FIRE DEPARTMENT

Re: Review of Rooftop Access Plan
320 Park Place, Brooklyn, NY 11238
Block: 1165 Lot: 34 **Bin # 3029102**
Fire Prevention FPIMS No. 36053528

PROJECT:
WARNKE RESIDENCE
320 PARK PL
BROOKLYN, NY 11238

A - 100.00
PAGE # 2 OF 4

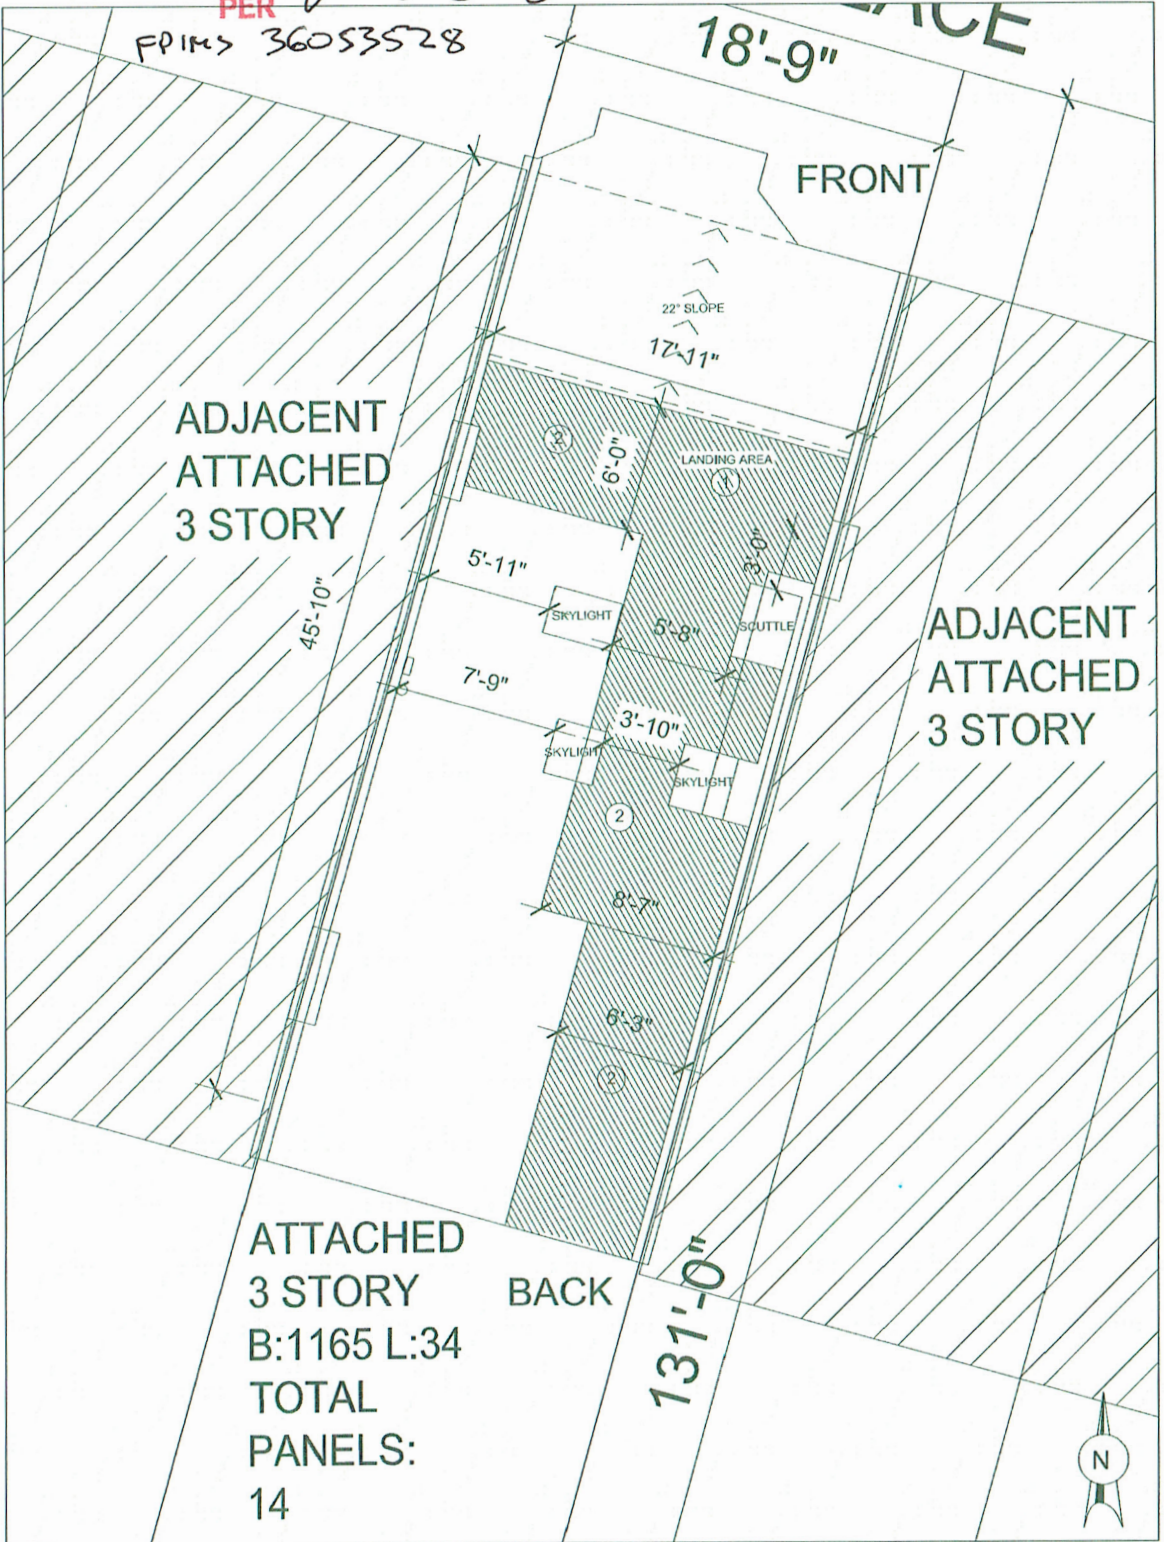
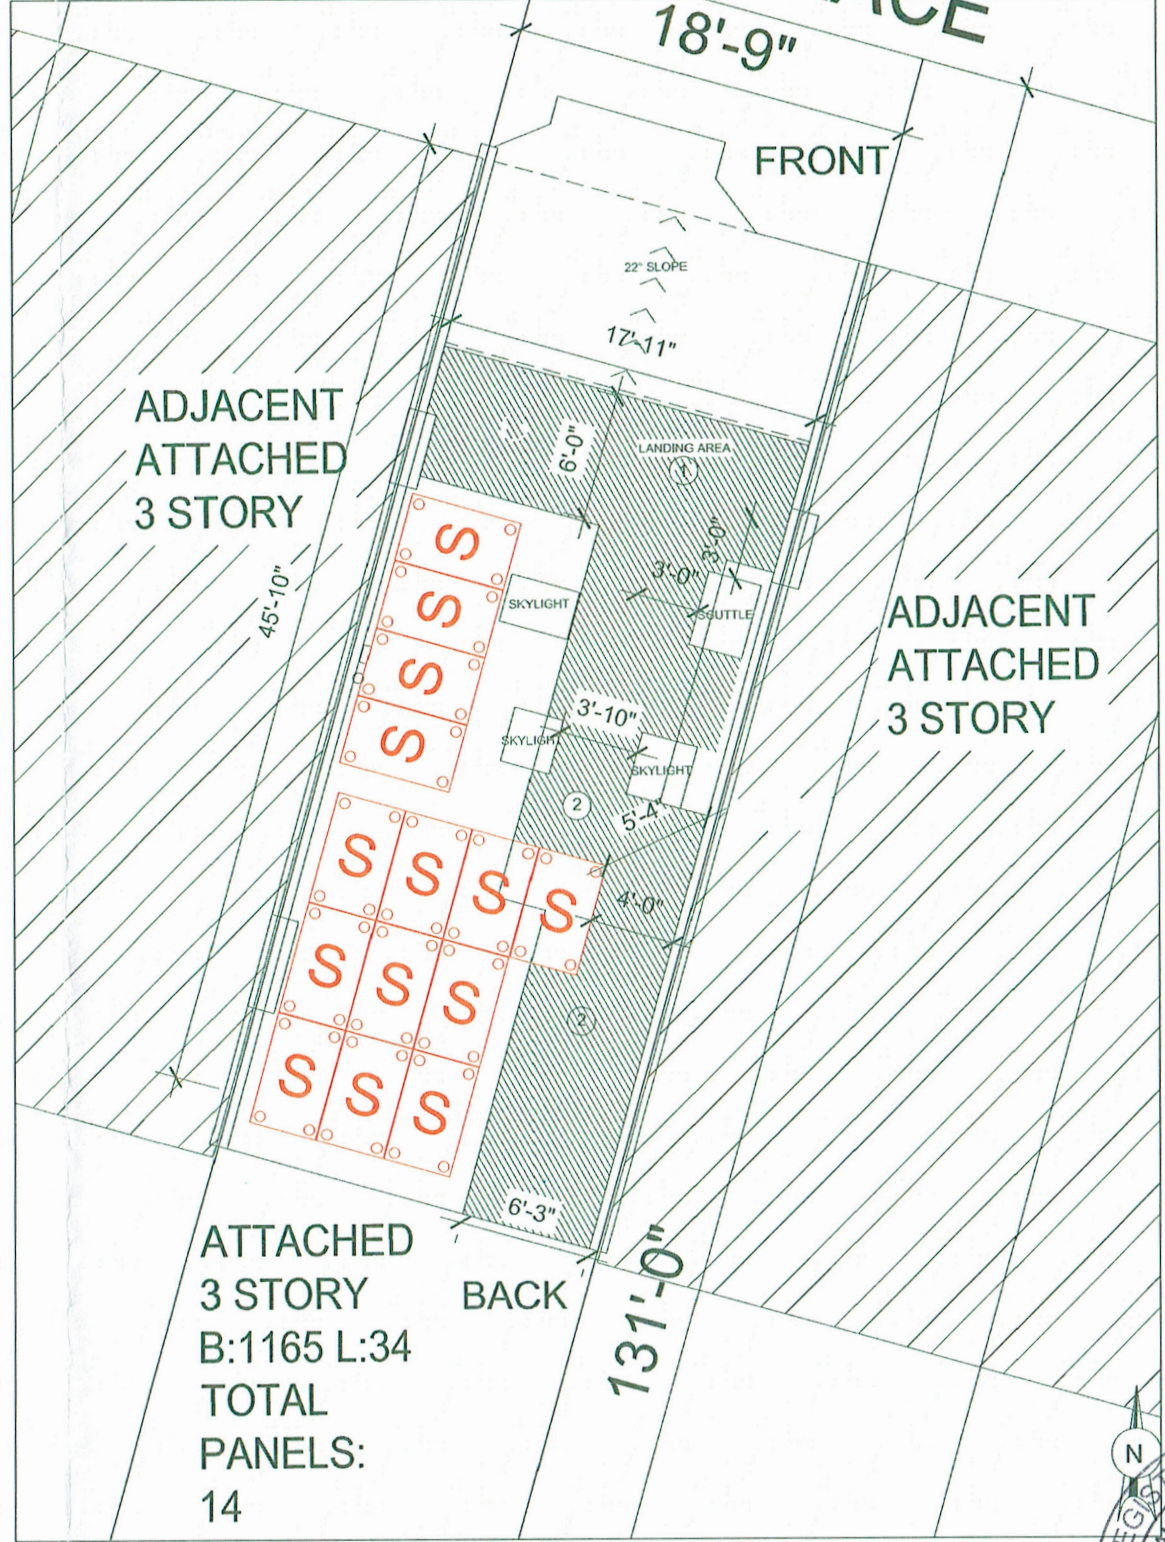
Your modification application and accompanying rooftop plan **A-100.00** dated **November 18, 2015** indicates that you are unable to comply with the minimum clearance and design requirements for rooftop access and/or clear path requirements of FC 504.4 primarily because of the following existing rooftop condition and/or proposed rooftop alteration:

- Existing skylights and proposed solar panels limit clear path from front to rear on the rooftop.

In lieu of complying with FC504.4, your rooftop plan **A-100.00** dated **November 18, 2015** provides 18 feet of rooftop perimeter access on the Park Place exposure, connected to a clear path from the front of the building to the rear and from one side of the building to the other.

Your rooftop plan **A-100.00** dated **November 18, 2015** provides adequate Fire Department access to and upon the rooftop. Accordingly, your application for a modification is **GRANTED**, subject to the following conditions:

1. This determination only modifies compliance with respect to the rooftop access and/or clear path requirements specifically set forth above. This determination does not modify your obligation to comply with other applicable provisions of FC504.4, including the marking and signage requirements of FC504.4.7 and 504.4.8.

3. The approved modified rooftop access and/or clear path requirements as indicated on architectural drawing **A-100.00** dated **November 18, 2015**, shall be constructed and maintained in accordance with the approved rooftop plan and maintained clear of obstructions and kept available for emergency responders. If any change is necessary, a new application shall be submitted to modify them.
